project: COLD STORE & OFFICES
ENTERPRISE WAY
SPALDING

drawing: OFFICE FLOOR PLANS

drawing no.: 6455/02

revision: J

FIRST FLOOR PLAN

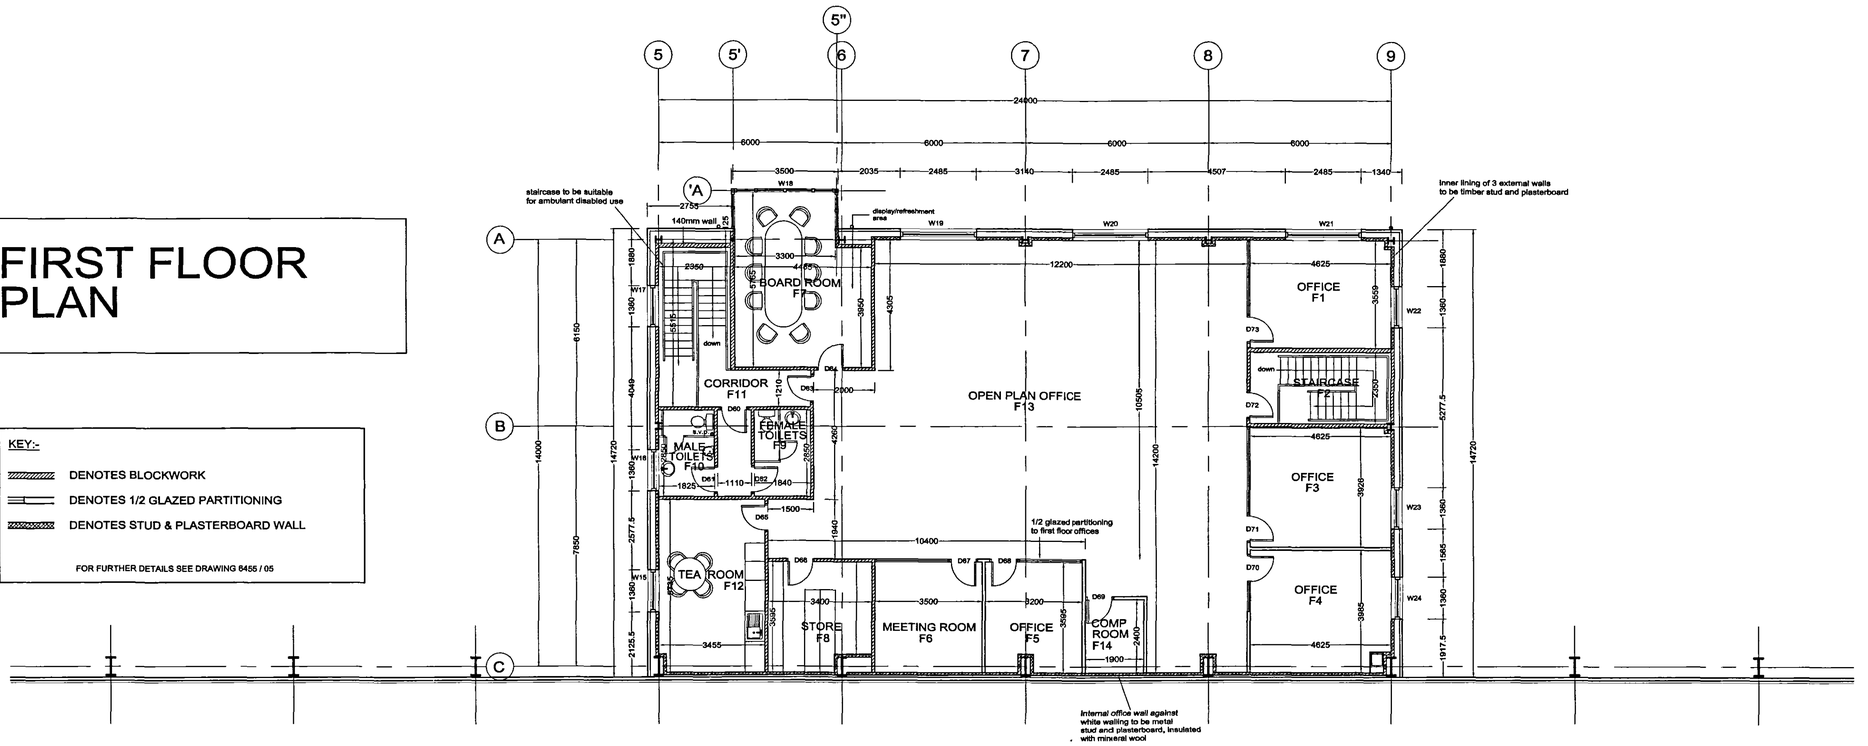
Revision G: 24/09/99.
G25/F2 staircase updated to tie in with birchwood drawings. First floor wall construction updated to studwork, where shown. Cleaners sink omitted from G20 and stainless steel cleaners sink added to G28, in accordance with clients instructions. Sink shown in F12 Tea Room.

Revision F: 19/8/99.
1/2 glazed partitioning added to canteen. D39 mirrored. D11 removed. D12 enlarged. Wall construction between offices and cold store revised. Wall type indicated on first floor plan. Notation added. Units added to canteen.

Revision D: 30/7/99.
F2 Staircase moved towards g/f B, first aid room enlarged. First floor storeroom and office layouts revised. Further details added to tea room. First floor toilets changed to ambulent toilets. 1/2 glazed partitioning added to first floor offices. Computer room reduced and moved.

GROUND FLOOR PLAN

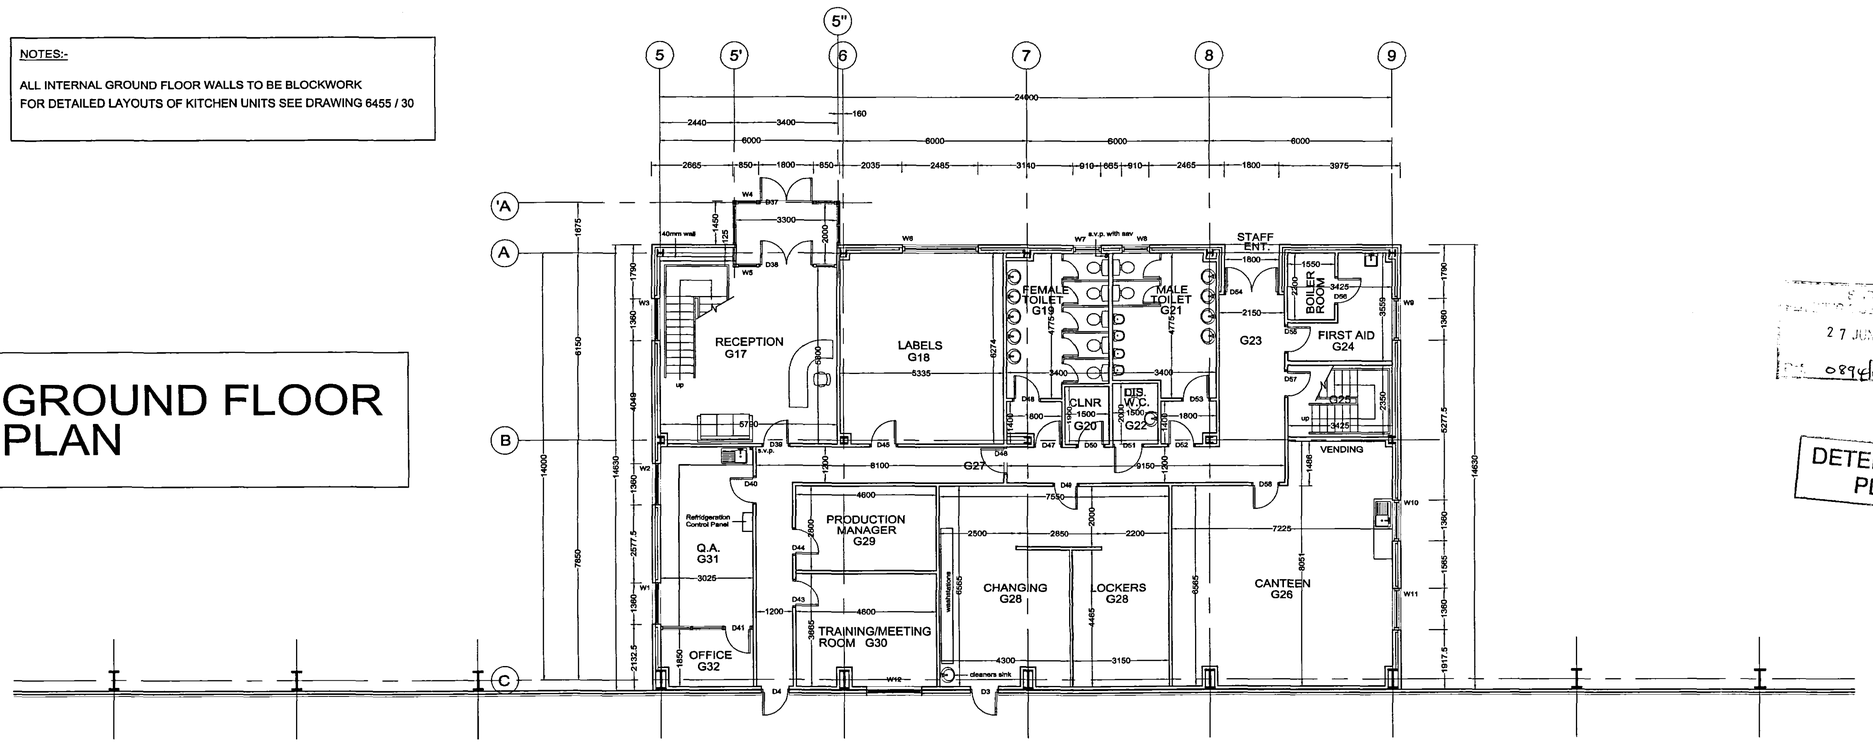
Revision J: 14/10/99.
Refridgeration control panel and additional worktops added to Q.A. Room G31. Door 3 hung on opposite side.

Revision I: 07/10/99.
Alterations to layout of Computer & QA rooms.

Revision H: 29/09/99.
Kitchen layouts updated, internal lining to walls corrected, 1/2 glazed partition in canteen removed.

Revision E: 16/8/99.
Wall construction between offices and cold stores, and on G17 staircase wall adjacent to gridline A revised.

Revision C: 28/6/99.
Columns encasement shown. Wall between offices and factory revised, rooms F5, F6, F8, F12 and F14 amended to tie in with changes. Wash station moved in G28.

Revision B: 21/6/99.
Canteen division revised and vending area shown. Boiler room moved to First Aid room.

Revision A: 14/6/99.
Revision in accordance with clients comments dated 9/6/99. Store F8 width increased. Computer room F14 width decreased. SVP shown in G19, G32 and F10. Internal window from F4 removed. Column orientation GL A changed and GL B. Boiler room added in G25. Dividing wall in G28 and extra door added. Sinks shown in G24 and G26. Screen and door omitted from corridor G23. Dimensions added.
